ENVIRONMENTAL ASSESSMENT REPORT

Name of Applicant: Cameron LNG, LLC (Cameron)

Docket No: CP15-560-000

Cameron LNG Expansion Project

Figure 3: Location of the Momentum Barrier.

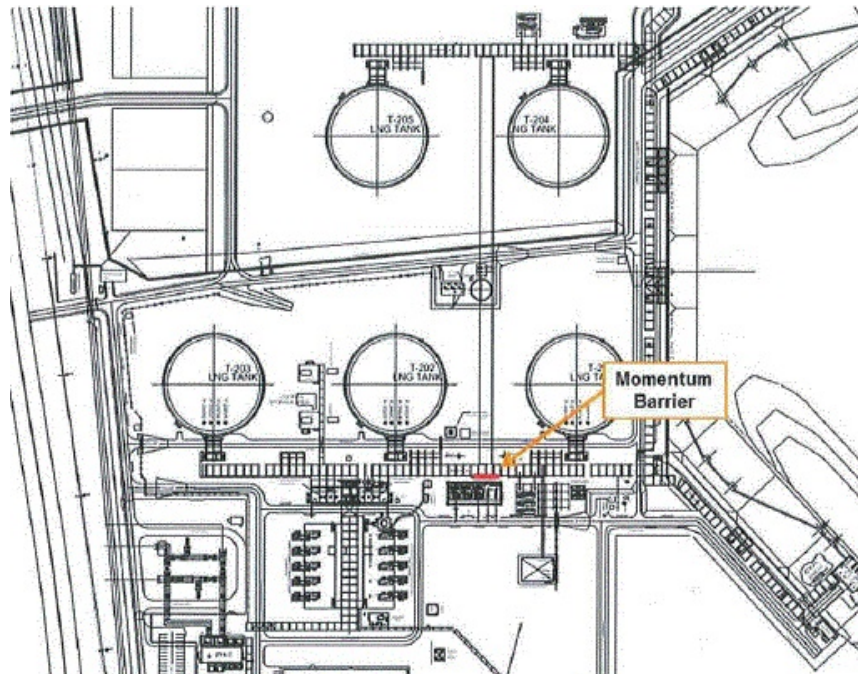
Scenario 3 in table 2.7-4 shows the 2-inch hole release from the 30-inch-diameter sendout header. Cameron LNG proposed to install a jet-momentum barrier located 18 feet downstream of the potential release location in order to break up the momentum of the LNG jet from this release. The barrier would be attached to the pipe rack structure and would be 8.9 feet above ground level. The barrier would measure 46 feet wide and 26 feet tall. Figure 3 shows the location of the momentum barrier. In order to ensure that the jet-momentum barrier is maintained throughout the life of the facility, **we recommend that:**

- Prior to construction of the final design, Cameron LNG should file with the Secretary for review and written approval by the Director of OEP the procedures to maintain and inspect the barriers provided to meet the siting provisions of 49 CFR 193.2059. This information should be filed a minimum of 30 days before approval to proceed is requested.**

Figure 6: Flammable Vapor Exclusion for 2-inch Hole Release from the In-tank Pump Discharge Piping (Scenario 2).

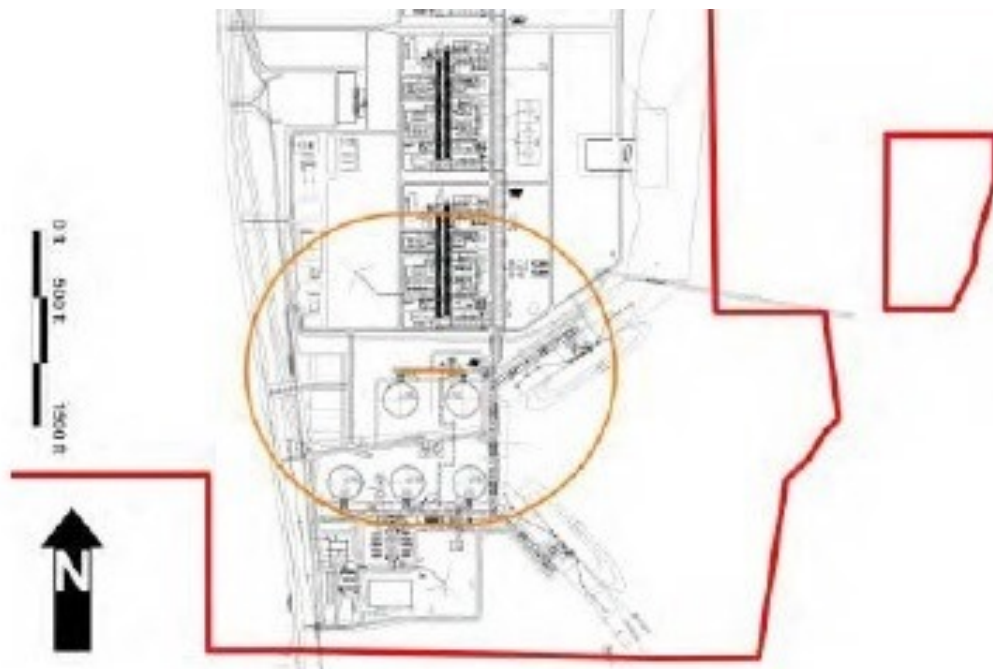
Figures 6 and 7 “Vapor Dispersion Design Spill Analyses for LNG” show the flammable vapor cloud from releases at the 30-inch diameter sendout- header would migrate under the LNG storage tanks. On December 16, 2015, Cameron LNG stated that the LNG storage tank will be designed to withstand the effects of overpressure from ignition of the vapor cloud under the tank. If necessary, measures will be included to mitigate the effect of potential blast overpressures, including measures to prevent flammable vapors from entering the space below the tank. Therefore, **we recommend that:**

Figure 13: Flammable Vapor Exclusion Zone from for a 4-inch Mixed Refrigerant Release (Scenario 1).

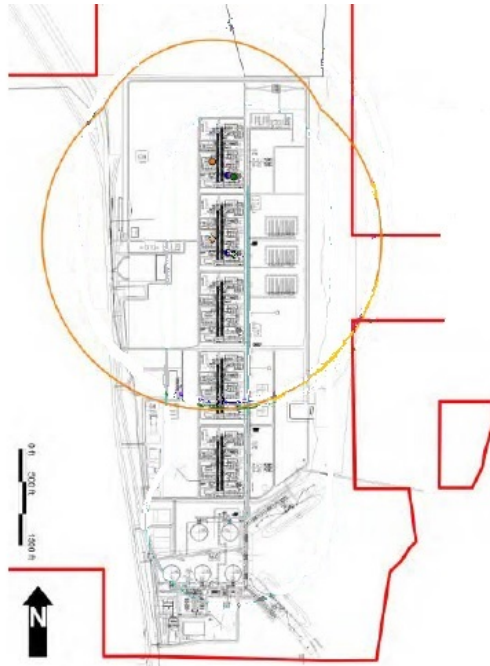
Figure 13 shows the vapor dispersion from the mixed refrigerant release would extend over the Calcasieu Ship Channel. In this case, the DOT has not objected to the flammable vapor dispersion hazards extending over a navigable waterway. The distances to the ½-LFL vapor cloud for all propane and heavy hydrocarbon release scenarios would remain within the Cameron LNG property. We conclude that the siting of the proposed project would not have a significant impact on public safety. If the facility is constructed and operated, compliance with the requirements of 49 CFR 193 would be addressed as part of DOT’s inspection and enforcement program.

Figure 18: Distance to the Hazardous Atmosphere for a 3-inch Liquid Nitrogen Release from the Liquid Nitrogen Storage Area

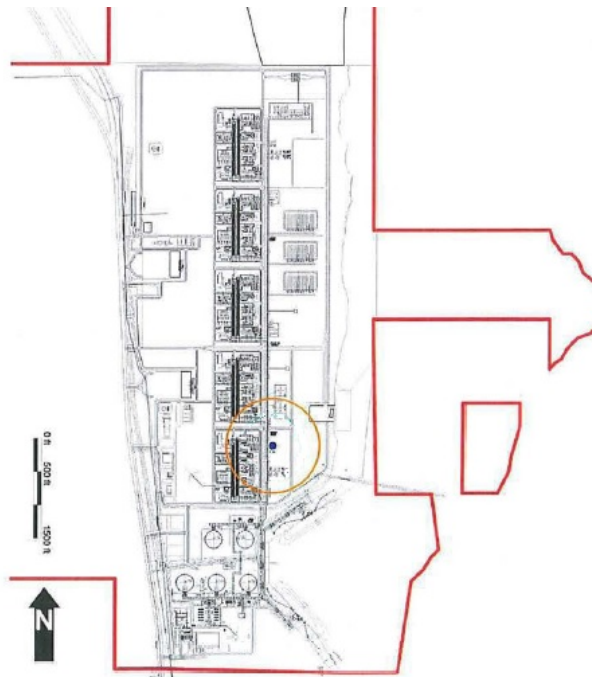
The PHAST results indicate the endpoint distance of 705 feet, and Figure 18 indicate that the nitrogen vapor would remain within Cameron LNG’s property. As a result, we conclude that the siting of the proposed project would not present a significant impact to the public with respect to asphyxiate hazards. If the facility is constructed and operated, compliance with the requirements of 49 CFR 193 would be addressed as part of DOT’s inspection and enforcement program. Cameron LNG also proposes to consult with the nitrogen system supplier regarding safe practices and design. In order to limit the risk of asphyxiate hazards, we recommend that:

Figure 19: Vapor Cloud Explosion of Mixed Refrigerant at Liquefaction Trains

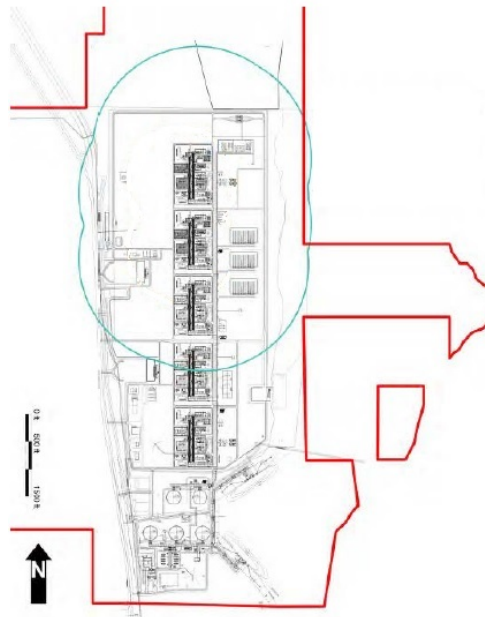
Figure 19 shows that the overpressure from mixed refrigerant vapor cloud explosion would extend over the new firewater tank, refrigerant storage area, and trucking area. Cameron LNG also proposes evaluate the effect of vapor cloud explosions on fire protection equipment and occupied buildings during the detailed design phase. Therefore, **we recommend that:**

Figure 19 also shows the 1-psi overpressure would extend over Cameron LNG’s property into the water channel. In this case, the DOT has not objected to the 1-psi overpressure due to vapor cloud explosion extending over a navigable waterway. Based on Cameron LNG’s overpressure analysis and our recommendations, we conclude that the siting of the proposed project would not have a significant impact on public safety due to vapor cloud explosion events. If the facility is constructed and operated, compliance with the requirements of 49 CFR 193 would be addressed as part of DOT’s inspection and enforcement program.

Figure 21: Thermal Radiation Exclusion Zones

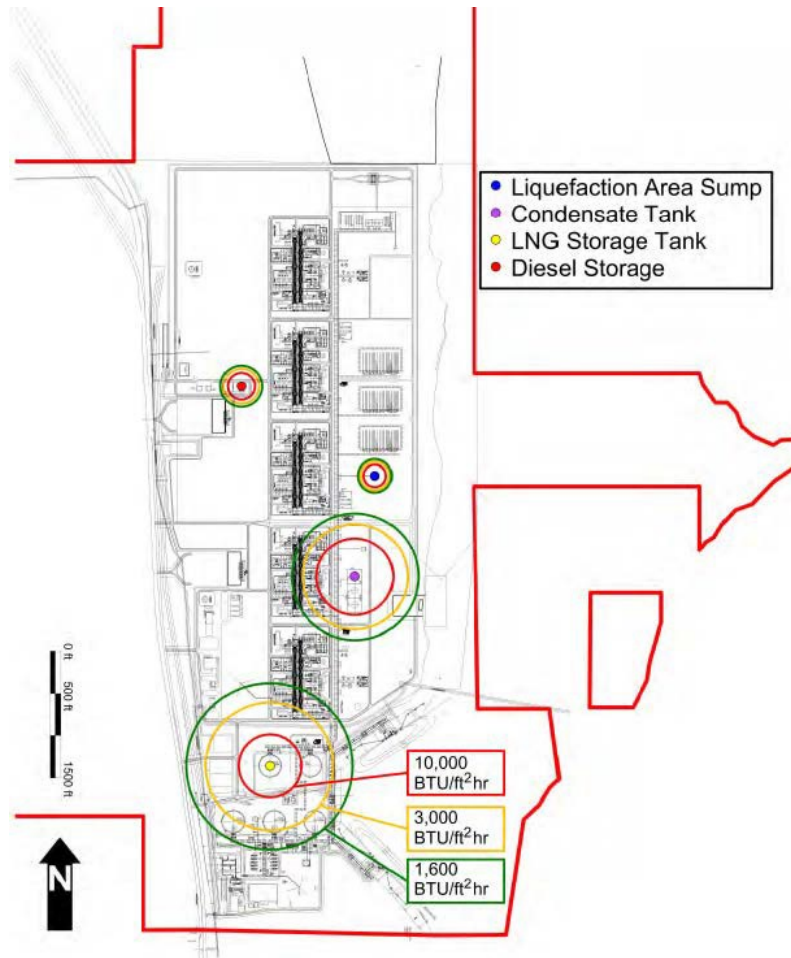
The 10,000-, 3,000-, and 1,600-Btu/ft²-hr heat fluxes from the LNG storage tank and the 1,600-Btu/ft²-hr heat flux from the LNG storage tank, the new Liquefaction Train Impoundment, the stabilized condensate storage tank dike, and diesel tank dike would remain within the facility property lines. Cameron LNG also evaluated jet fires from the design spills using PHAST version 6.7. The results showed that the jet fire radiant heat to 1,600 BTU/ft²-hr for the design spills would remain within the Cameron LNG property. As Cameron LNG’s calculations show the radiant heat limits for pool fire and jet fire scenarios would stay within Cameron LNG property, we conclude that the siting of the proposed project would not have a significant impact on public safety with regard to thermal radiation from fires. If the facility is constructed and operated, compliance with the requirements of 49 CFR 193 would be addressed as part of DOT’s inspection and enforcement program.
